HISTORIC AND DESIGN REVIEW COMMISSION

March 19, 2025

HDRC CASE NO: 2025-052
ADDRESS: 332 FLORIDA ST
LEGAL DESCRIPTION: NCB 3010 BLK 8 LOT 8-9, N 46 FT OF 17 & N IRR 33 FT OF 18
ZONING: RM-4 CD, H
CITY COUNCIL DIST.: 1
DISTRICT: Lavaca Historic District
APPLICANT: Nathan Manfred/French and Michigan
OWNER: Mae Miranda/MIRANDA FRANCISCO J & MAE H
TYPE OF WORK: Exterior Porch Addition
APPLICATION RECEIVED: February 26, 2025
60-DAY REVIEW: April 27, 2025
CASE MANAGER: Bryan Morales

NORTH ELEVATION - NEW AWNING OVER REAR DOOR

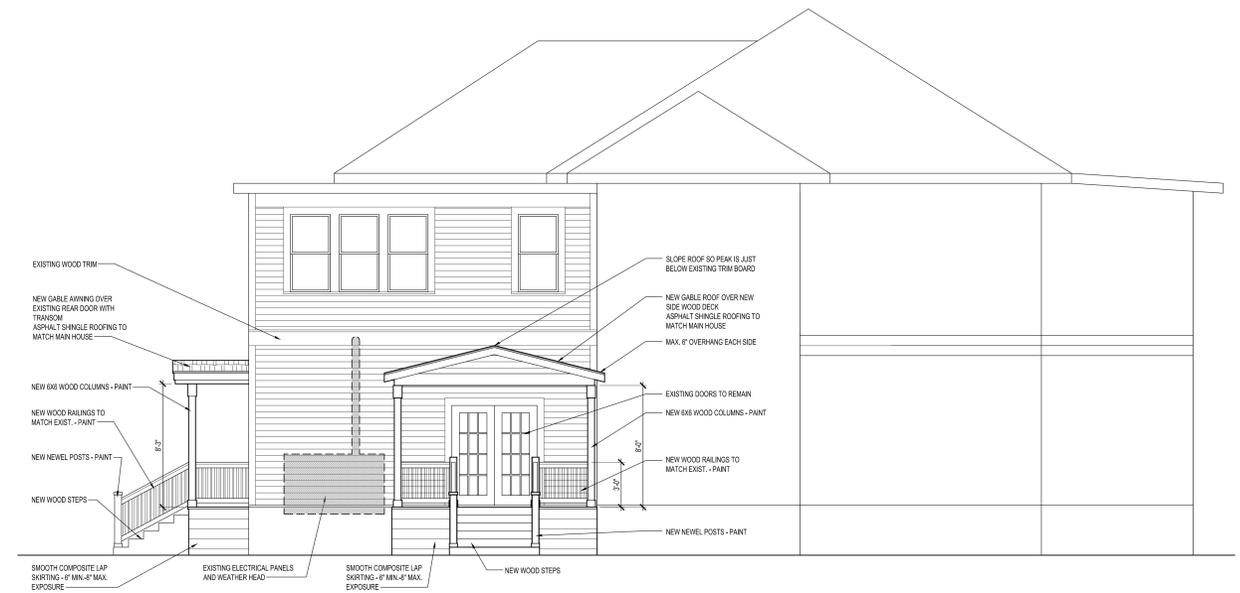
- i. SOUTH SIDE PORCH ADDITION (MASSING & FOOTPRINT) – The applicant is requesting approval to construct an approximately 19 sf 1-story covered rear porch on the primary structure's south side. The existing primary structure and detached rear accessory structure are 2-stories in height. Additions 1.B.i stipulates residential additions should be designed to be subordinate to the principal façade of the original structure in terms of scale and mass. Additions 2.B.iv states the building footprint should respond to the size of the lot. An appropriate yard to building ratio should be maintained for consistency within historic districts. Residential additions should not be so large as to double the existing building footprint, regardless of lot size. Staff finds the proposal generally appropriate.

- j. SOUTH SIDE PORCH ADDITION (ROOF FORM) – The applicant has proposed to install a gabled roof facing the rear of the property. The roof form of the rear porch addition will be visible from the public right-of-way from Boerne St. Additions 1.A.iii stipulates that residential additions should utilize a similar roof pitch, form, overhang, and orientation as the historic structure. Staff finds the proposed roof form generally appropriate.

3 WEST ELEVATION - NEW COVERED WOOD DECK
SCALE: 1/4" = 1'-0"

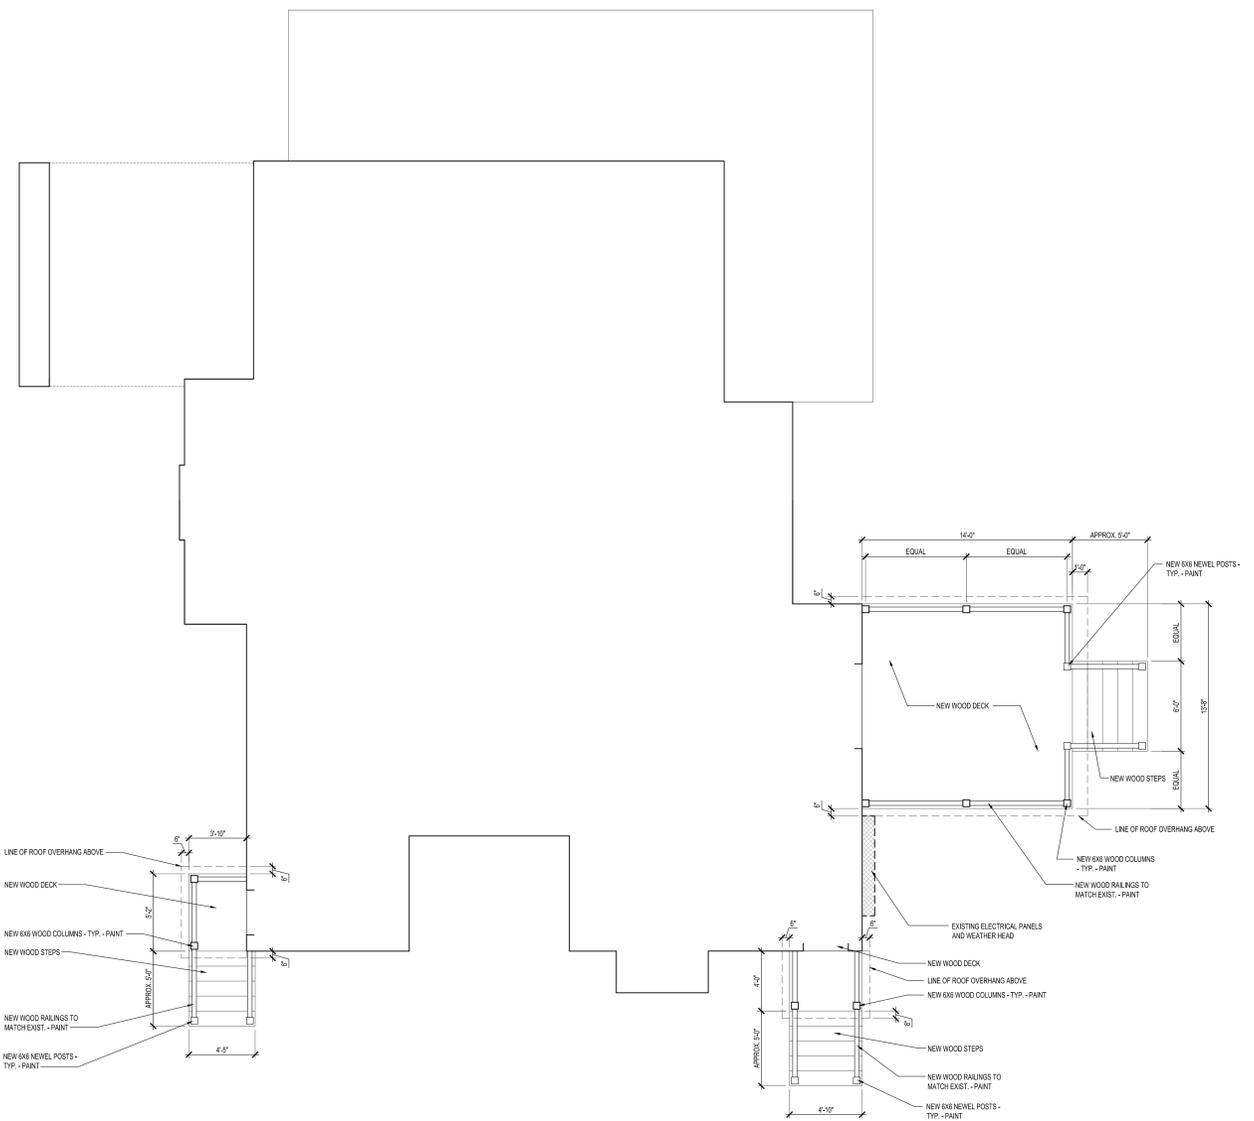
- d. EAST SIDE PORCH ADDITION (MASSING & FOOTPRINT) – The applicant is requesting approval to construct an approximately 190 sf 1-story covered side porch on the primary structure's east side. The existing primary structure and detached rear accessory structure are 2-stories in height. Additions 1.B.i stipulates residential additions should be designed to be subordinate to the principal façade of the original structure in terms of scale and mass. Additions 2.B.iv states the building footprint should respond to the size of the lot. An appropriate yard to building ratio should be maintained for consistency within historic districts. Residential additions should not be so large as to double the existing building footprint, regardless of lot size. Staff finds the proposal generally appropriate; however, the proposed depth of the eastern porch should be reduced to match the original porch depth

- e. EAST SIDE PORCH ADDITION (ROOF FORM) – The applicant has proposed to install a gabled roof facing Boerne St. The roof form of the side porch addition will be visible from the public right-of-way from Florida St and Boerne St. Additions 1.A.iii stipulates that residential additions should utilize a similar roof pitch, form, overhang, and orientation as the historic structure. Staff finds the proposed roof form generally appropriate.

- h. EAST SIDE PORCH ADDITION (ARCHITECTURAL DETAILS) – The applicant has proposed to construct a side porch addition to include square columns with simple capital and base trim, railing to match historic porch railing onsite, and steps. Additions 4.A.ii states additions should incorporate architectural details that are in keeping with the architectural style of the original structure. Details should be simple in design and compliment the character of the original structure. Architectural details that are more ornate or elaborate than those found on the original structure should not be used to avoid drawing undue attention to the addition. Additions 4.A.iii states applicants should consider integrating contemporary interpretations of traditional designs and details for additions. Use of contemporary window moldings and door surroundings, for example, can provide visual interest while helping to convey the fact that the addition is new. Staff finds the proposed architectural details of the side porch addition generally appropriate; however, the applicant should incorporate traditional 1x3" tongue and groove decking, foundation skirting to match existing skirting in-kind and reveal, and traditional fascia and soffit details.

- i. That the proposed depth of the eastern porch be reduced to match the original porch depth of approximately 8 feet.
- ii. That the applicant install porch decking featuring 1” x 3” tongue-and-groove members laid perpendicular to the attached wall plane.

- iii. That new wood columns be a maximum of 6x6” in width and feature a traditional cap and base and chamfered corners.
- iv. That the applicant install porch skirting to match historic skirting onsite.
- v. That the applicant provide updated construction documents incorporating stipulations approved by the HDRC for final review by staff prior to the issuance of a Certificate of Appropriateness.
- vi. That the applicant meets all setback standards as required by city zoning and obtain a variance from the Board of Adjustment if applicable.
